*XGMII Timing*

*Joel Dedrick*  
*PMC-Sierra*

**IEEE 802.3ae September Interim**  
**New Orleans, LA**

# Current Implementation, TX Side

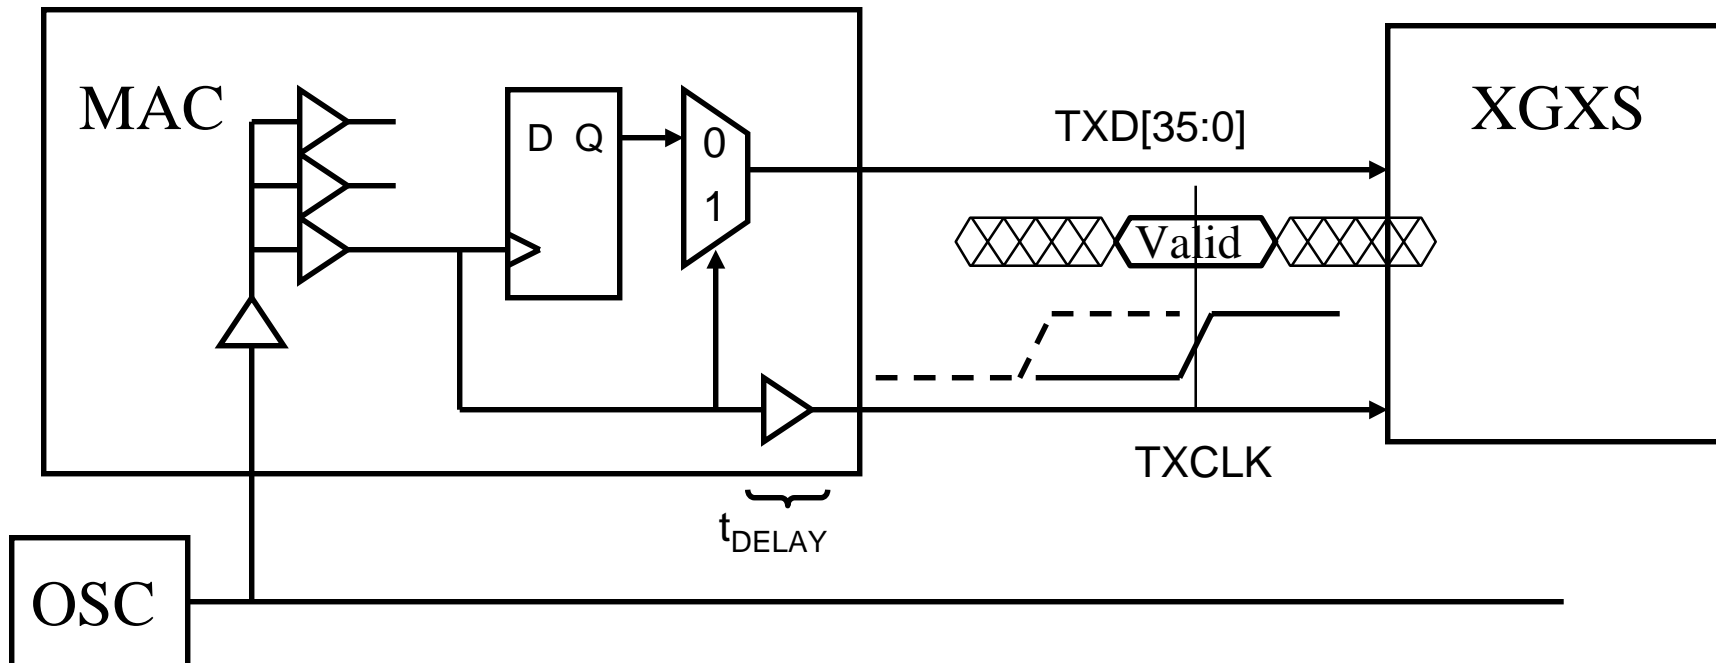
- To get 960 ps. setup time requires  $t_{\text{DELAY}}$  of  $> 960$  ps.
- But any delay in CMOS varies about 2.5x from fast corner process/voltage/temp to slow corner
- To guarantee 960 ps. fast corner requires  $>2.5$  ns. slow corner
- But a delay of 2.5 ns. leaves only 700ps. hold time (broken)
- The situation is really worse, since data skew must increase  $t_{\text{DELAY}}$

# Proposed TX Implementation

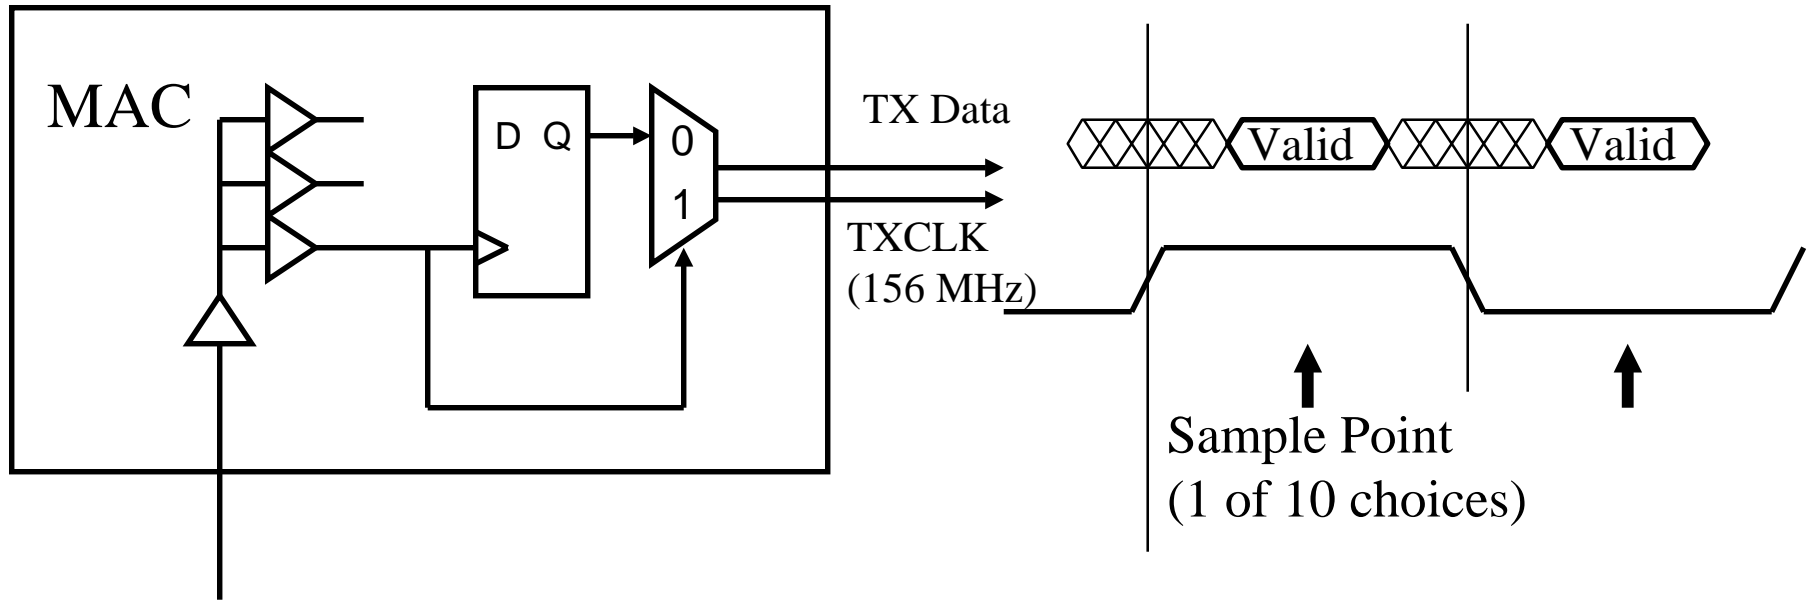
- **TX Direction - MAC: Source-simultaneous DDR clock**
  - Trivial to generate, even with ASIC toolflow
  - Best skew match with data, since it's just another data bit
- **XGXS: Locally generated sample clock**
  - XAUI bit clock gives 10 sample points per half period (320 ps. quantization error)
  - Adapts to changing process, temperature, etc.

# Proposed RX Implementation

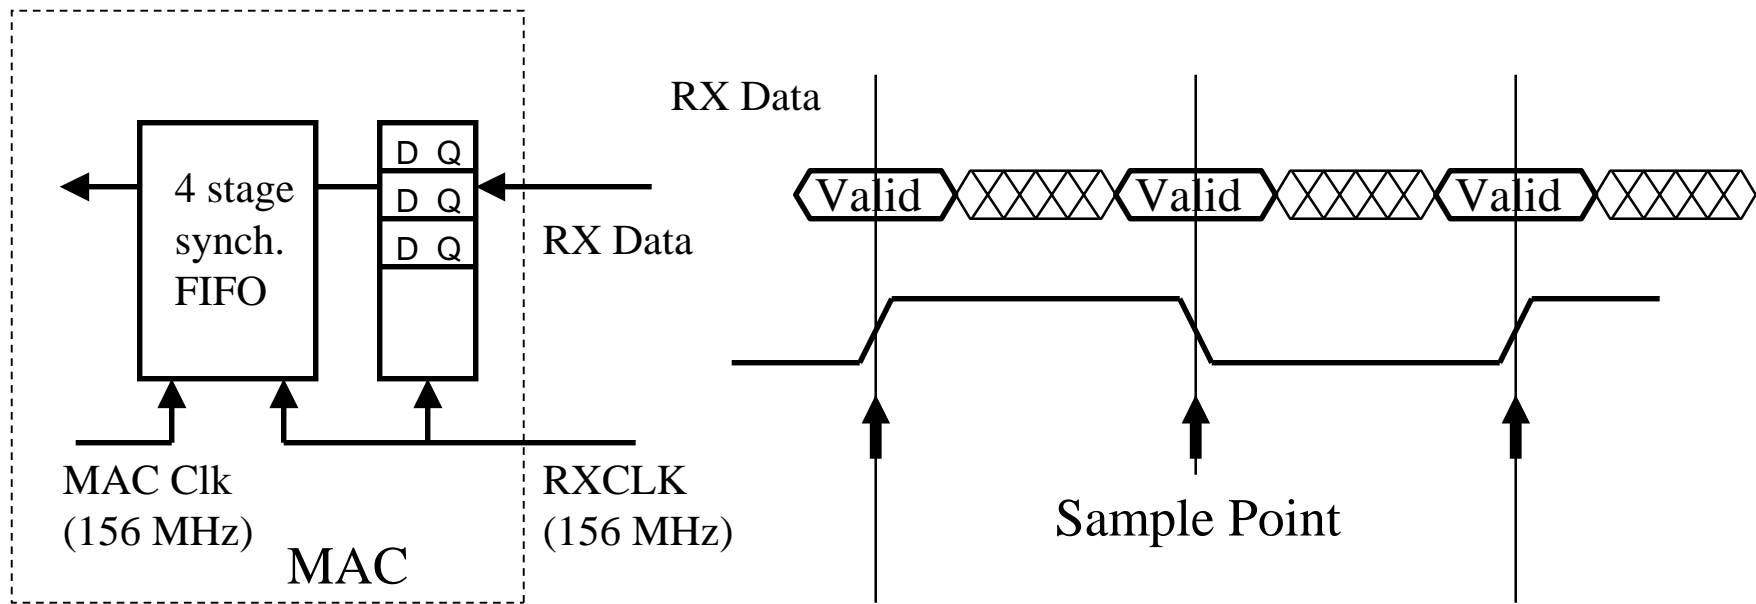
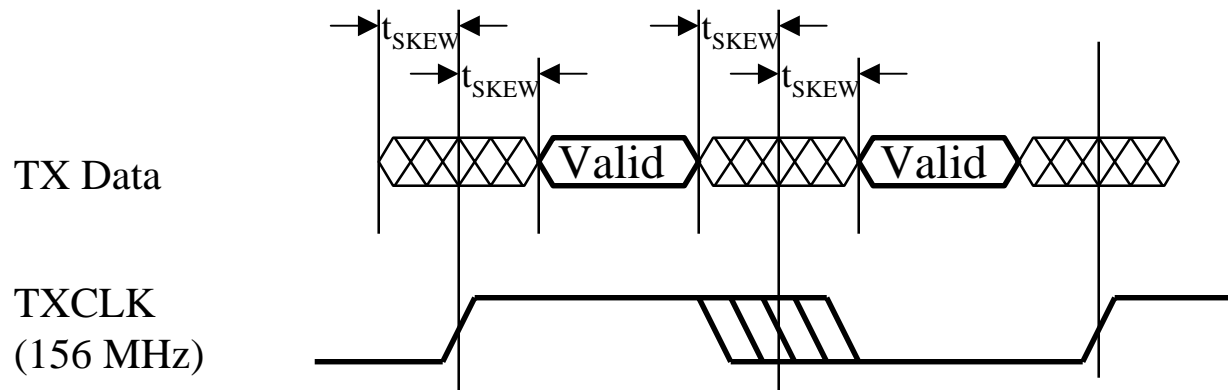
- **XGXS: Source-centered DDR clock**
  - XAUI bit clock provides a way to generate RXCLK at a precise timepoint, without resorting to delay buffers
- **RX Direction - MAC: Direct capture**
  - Trivial to use; directly sample the data, then FIFO to local phase domain
  - Simplest implementation for the MAC designer
